3.3 ECOLOGY AND WETLANDS COMMENTS AND RESPONSES

Figure 3.3-1: On-Site Delineated Wetlands
 Minisceongo Park
 Towns of Haverstraw & Ramapo, Rockland County, New York
 Source: Atzl, Scatassa & Zigler, P.C.
 Drawing Date: 1/13/09, rev. 8/18/09
 Scale: 1" = 170'

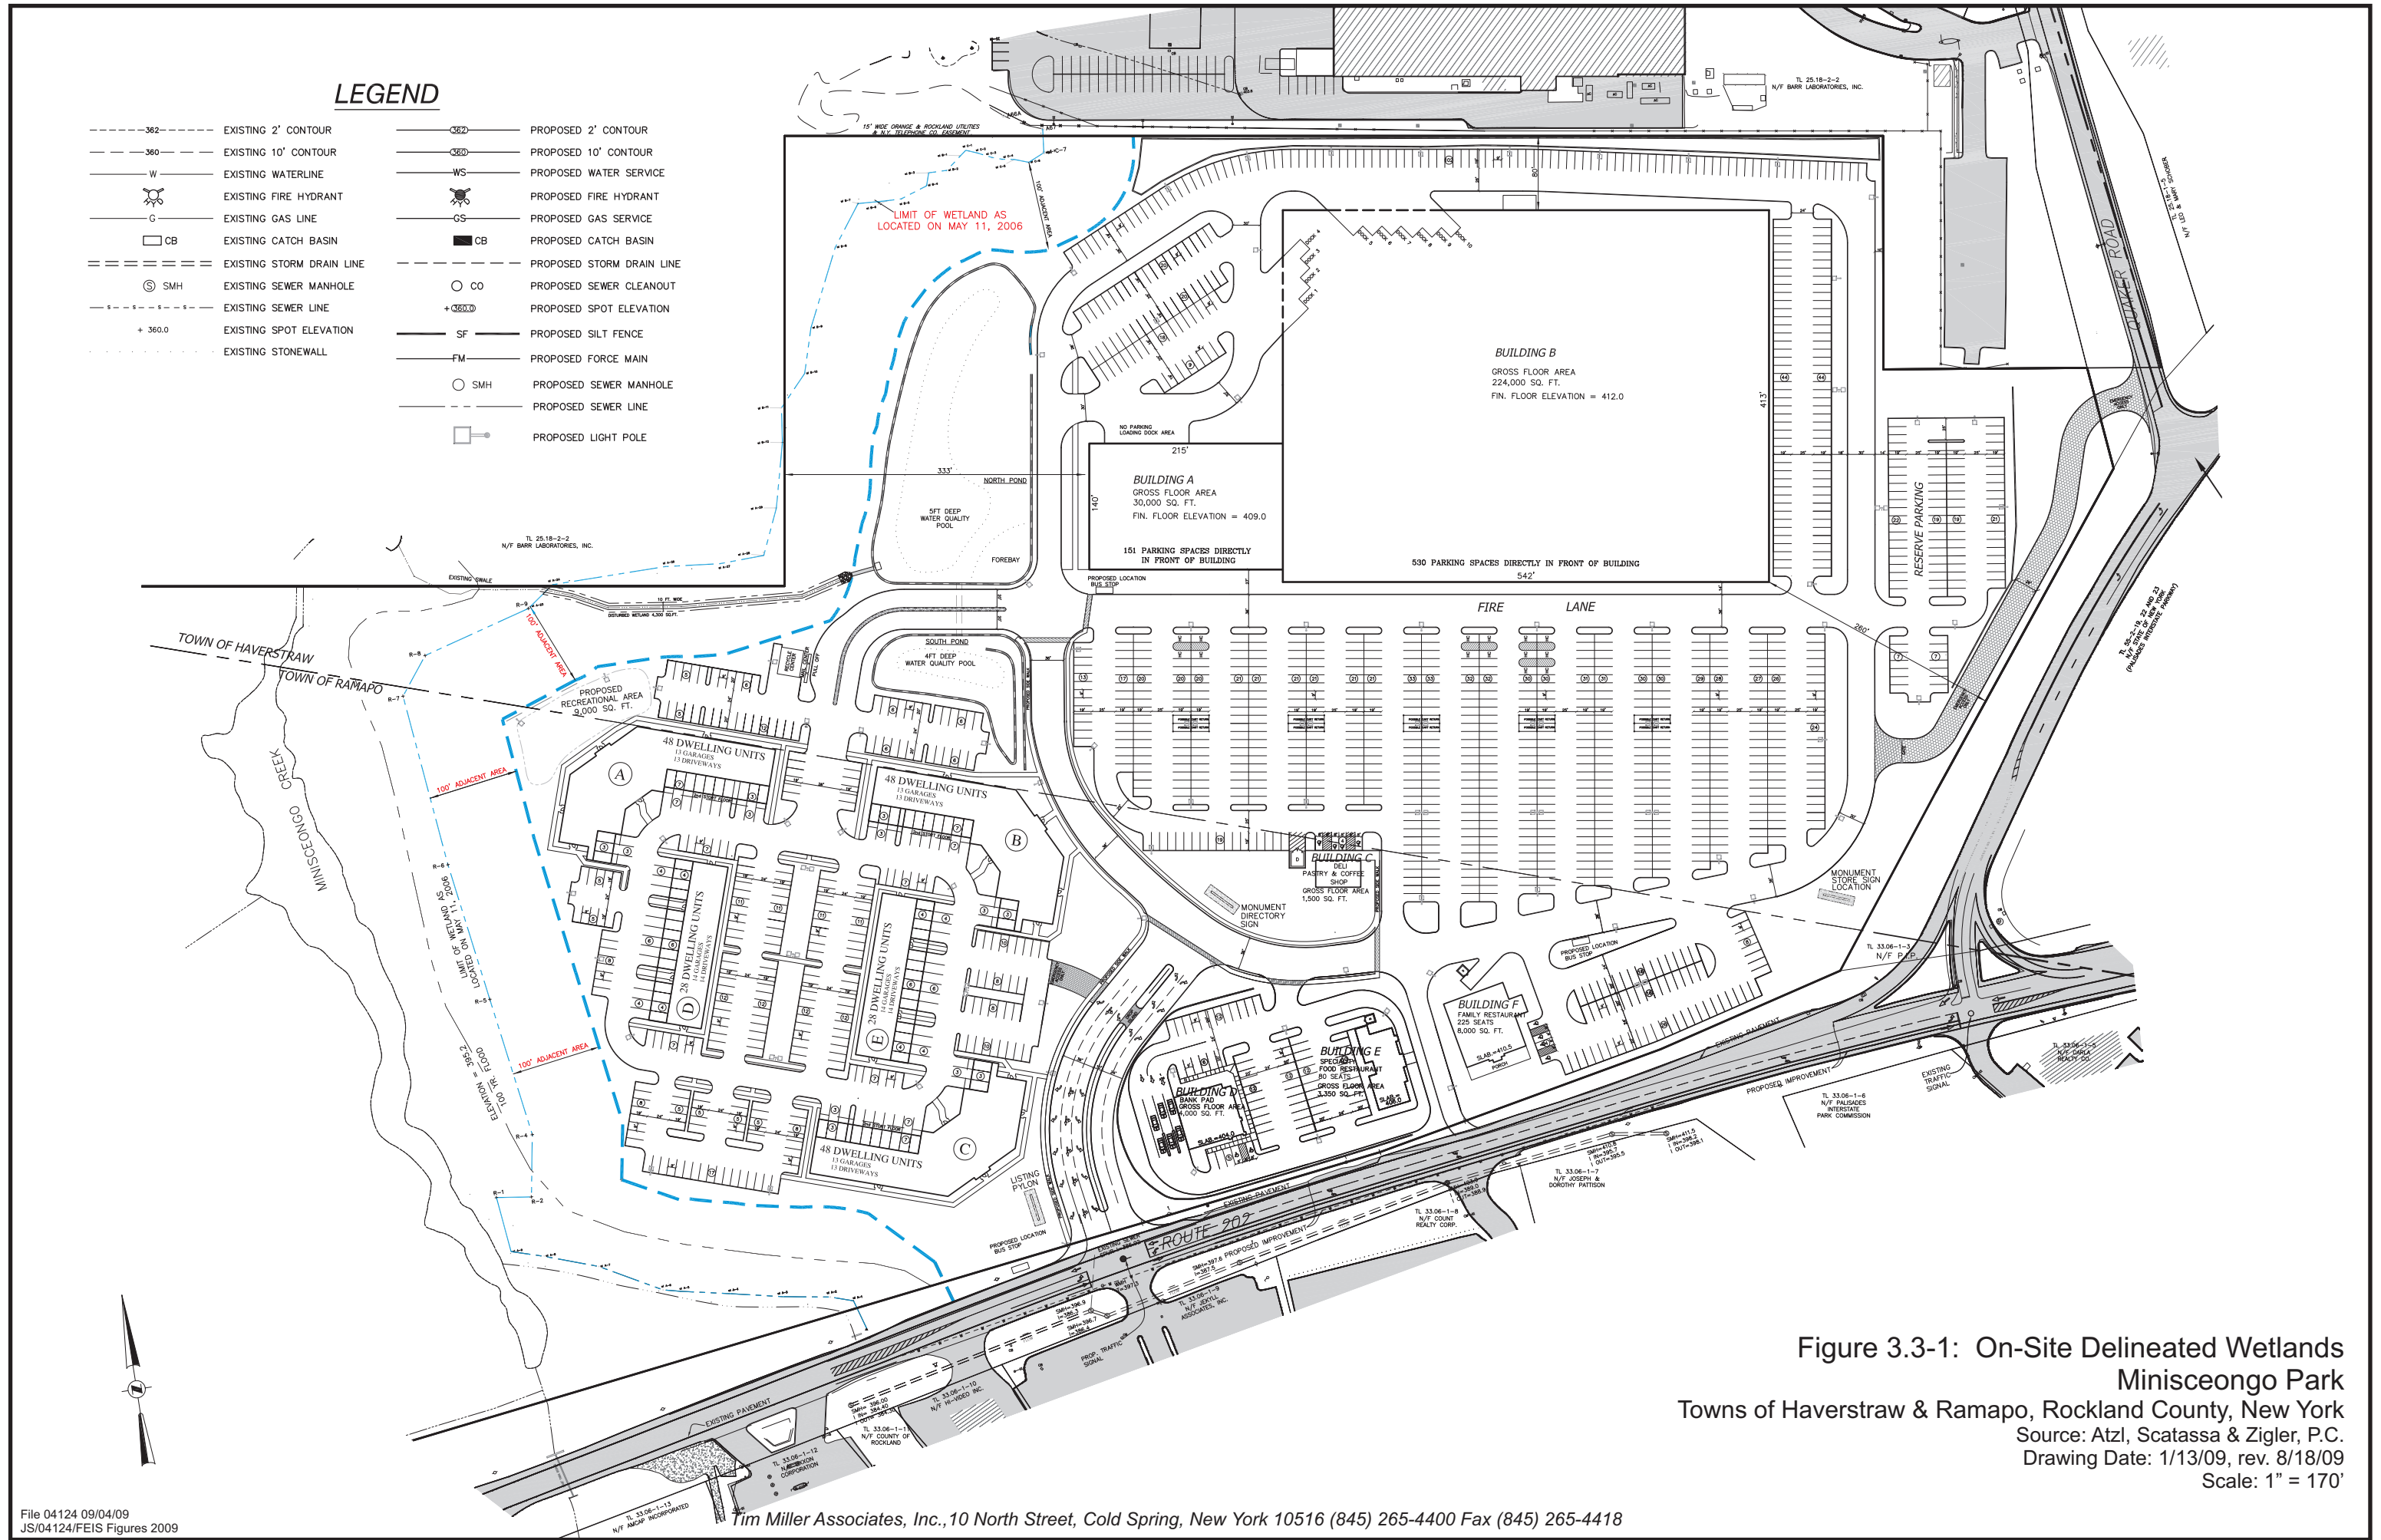
Comment 3.3-1 (Letter #1 Ralph P. Peragine, P.E., Stephan A. Maffia, P.E., Jay Snyder, and Anthony Agresti, TRC Engineers, Inc., March 4, 2009): The Figure provided is illegible (Figure 3.3-4). A legible Figure should be provided.

Could anybody show me on the map where exactly the wetlands technically begins? I know the state declaration line is different from what most people consider the swamp to be. So I'm kind of wondering what line is that up there?

***Response 3.3-1:** FSEIS Figure 3.3-1 - On-Site Delineated Wetlands is attached at the end of this section to replace the previous figure that was included in the SEIS document.*

Response 3.3-5: *Wetlands on the project site were delineated. The NYSDEC signed off on the wetland boundary map. With the exception of a small disturbance to the 100-foot adjacent area (0.41 acres) and wetland (0.03 acres) to accommodate a stormwater management facility outfall, no development is proposed within the wetlands on this project site. Filling which may or may not have occurred on other parcels in the study area is unrelated to the proposed development of Minisceongo Park.*
